Re: Quivira Mining Company - Amendment To Change Liner Material
Phased Disposal Tailings Cell
Ambrosia Lake, New Mexico

AMENDMENT TO CHANGE LINER MATERIAL

For The Phased Tailings Disposal Cells

Ambrosia Lake, New Mexico

FIGURE 1

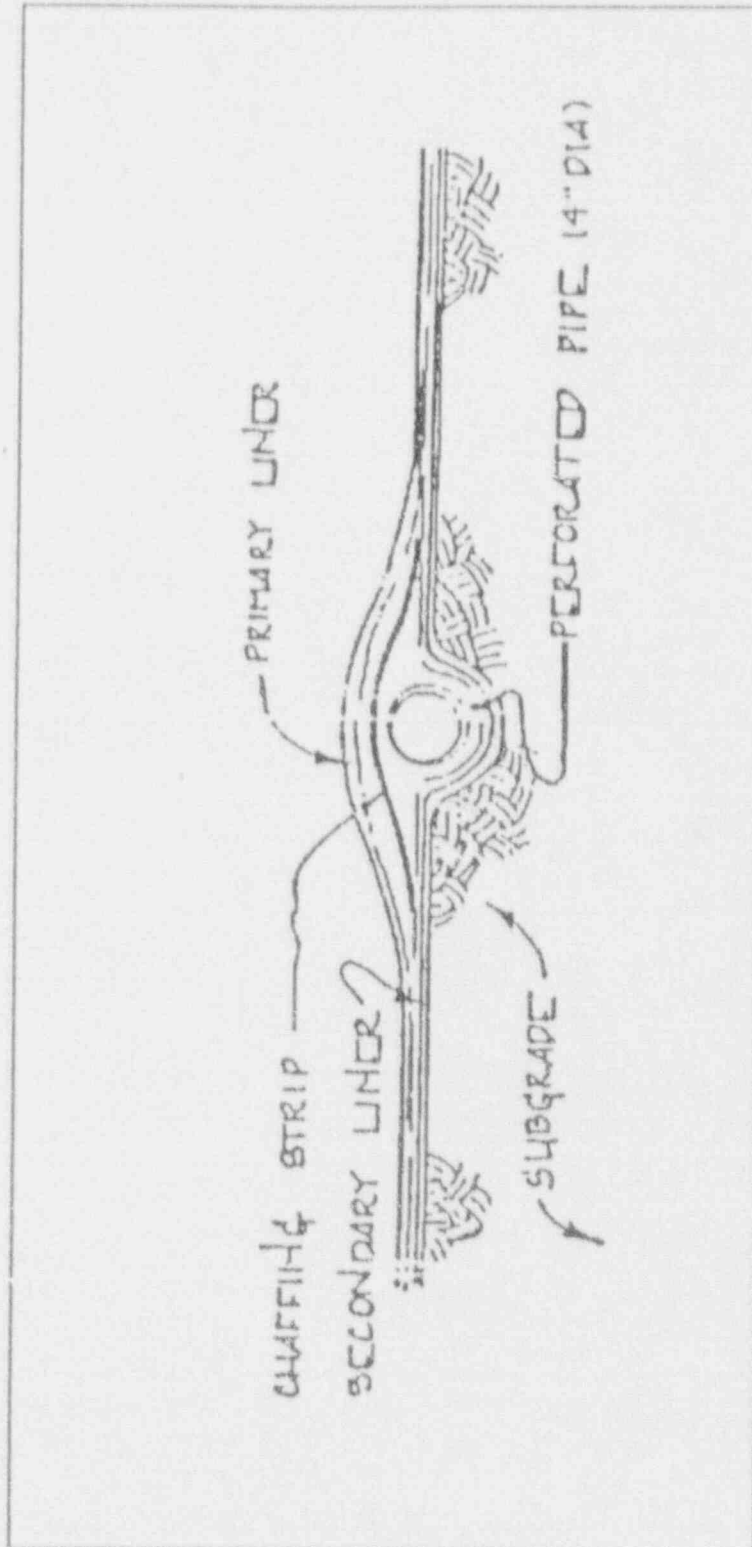
Construction of the double lined cell will begin by placement of a 40 mil HDPE bottom liner atop the compacted foundation. Individual geomembranes liner sections are overlapped from 2 to 7 inches and are "welded" creating a sealed HDPE seam. Upon completion of the installation of the bottom liner, the area and "welds" are inspected to assure proper geomembrane liner placement and acceptable welds. All areas deemed unsatisfactory will be repaired, rewelded or replaced.

The detection system and drainage net will be placed between the HDPE geomembranes in areas recessed in the middle of both sides and the cell floor. A typical cross section of the leachate collection/leak detection system within the geomembranes is shown in Figure 1.

FIGURE 2

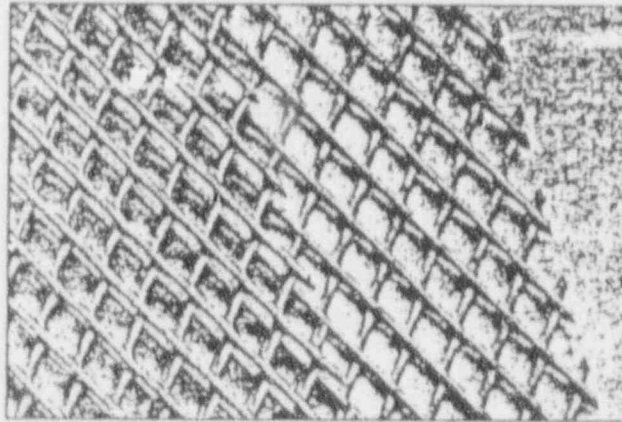
Quivira proposes to replace the approved interstitial 6 inch sand layer with HDPE drainage net. The HDPE drainage net will be installed along the side slopes of the cell due to slumping considerations. Since slumping is not a factor on the bottom of the cell, Quivira proposes that EPA approve the use of either the HDPE drainage net or the interstitial layer 6 inch sand layer on the bottom areas of the cell. Both provide the necessary support and transmissivity required in the leachate collection\leak detection system. The HDPE drainage net is built such that it provides a high transmissivity of fluids. This allows for quick detection and remedial action in the event of a leak. As such, the longitudinal drainage pipe (long side of cells) become unnecessary because of the quick drainage of solutions within the drainage net. All solutions will be collected by gravity flow within the sloped, center leachate collection\leak detection system.

The HDPE drainage net is constructed with the same material as the HDPE geomembrane liner and is a profiled mesh made by extruding two sets of HDPE strands together forming a diamond shape. The drainage net exceeds RCRA guidelines for transmissivity of fluids in a leak detection system. Figure 2 shows the interstitial HDPE drainage net.

The two (2) leak detection monitoring stations are located in the middle of the cells on each side of the longer embankments. Gravity flow is provided by the 0.3%
